SUBJECT: PALO VERDE NUCLEAR GENERATING STATION, UNITS 1, 2, AND 3 -
ISSUANCE OF AMENDMENTS RE: REVISION TO TECHNICAL
SPECIFICATION 3.5.5, "REFUELING WATER TANK (RWT)" (TAC NOS.
ME0132, ME0133, AND ME0134)

SAFETY EVALUATION BY THE OFFICE OF NUCLEAR REACTOR REGULATION
RELATED TO AMENDMENT NO. 177 TO FACILITY OPERATING LICENSE NO. NPF-41,
AMENDMENT NO. 177 TO FACILITY OPERATING LICENSE NO. NPF-51, AND
AMENDMENT NO. 177 TO FACILITY OPERATING LICENSE NO. NPF-74
ARIZONA PUBLIC SERVICE COMPANY, ET AL.
PALO VERDE NUCLEAR GENERATING STATION, UNITS 1, 2, AND 3
DOCKET NOS. STN 50-528, STN 50-529, AND STN 50-530

FIGURE 3.5.5-1
Minimum Required RWT Volume

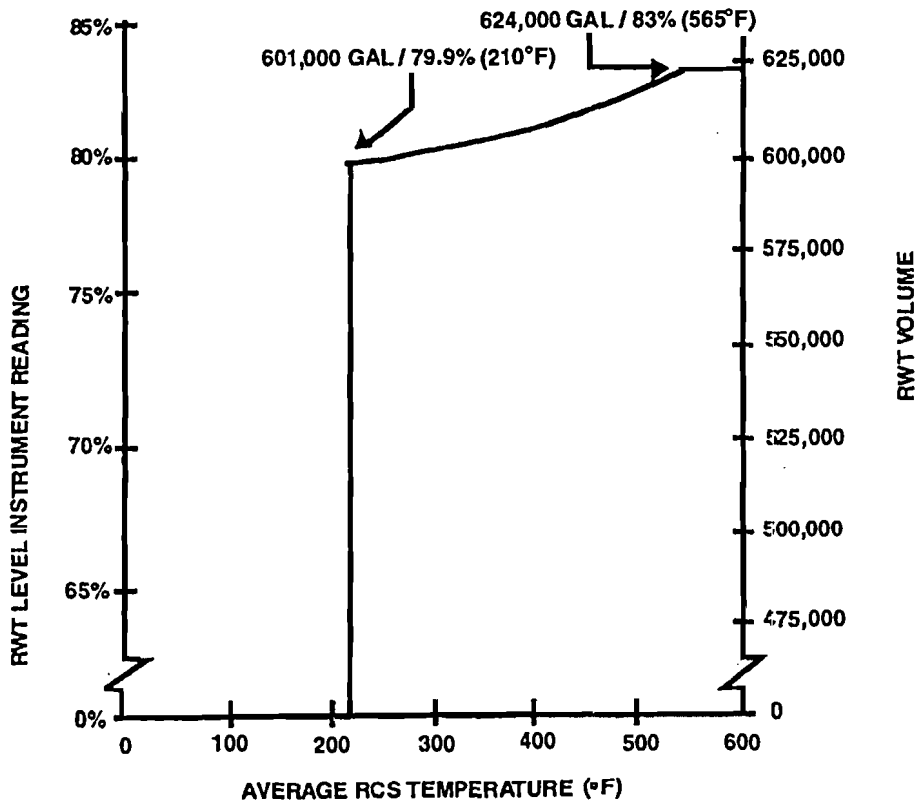
The amendments modify TS 3.5.5, "Refueling Water Tank (RWT)," for PVNGS, Units 1 and 3 to increase the minimum required RWT level indications and the corresponding borated water volumes in TS Figure 3.5.5-1, "Minimum Required RWT Volume," by 3 percent. In addition, the proposed amendments would incorporate editorial changes to TS Figure 3.5.5-1 for PVNGS, Units 1, 2, and 3, to provide consistent formatting of the RWT volumetric values provided in the figure.

The NRC staff has reviewed the licensee's proposed TS changes and supporting evaluation to increase the minimum required RWT levels and the corresponding borated water volumes in TS Figure 3.5.5-1 by 3 percent for PVNGS Units 1 and 3. The proposed changes comply with the requirements of 10 CFR 50.36(c)(3) and 10 CFR 50.46(b)(5) and GDCs 13, 16, 20, 35, and 38, and are consistent with the guidance of NRC GL 2004-02, RG 1.82, and RG 1.105. The proposed TS changes will assure that there is adequate water volume available in the containment to meet the functional requirements of the ESF pumps and the containment sump strainers for applicable design-basis accidents. These changes conform to the prior change approved by the NRC staff in Amendment No. 169 for PVNGS, Unit 2. In addition, the revisions to the labels in TS Figure 3.5.5-1 are editorial changes that will improve the clarity of the figure for PVNGS Units 1, 2, and 3. Therefore, the NRC staff has concluded that the proposed TS changes are acceptable.
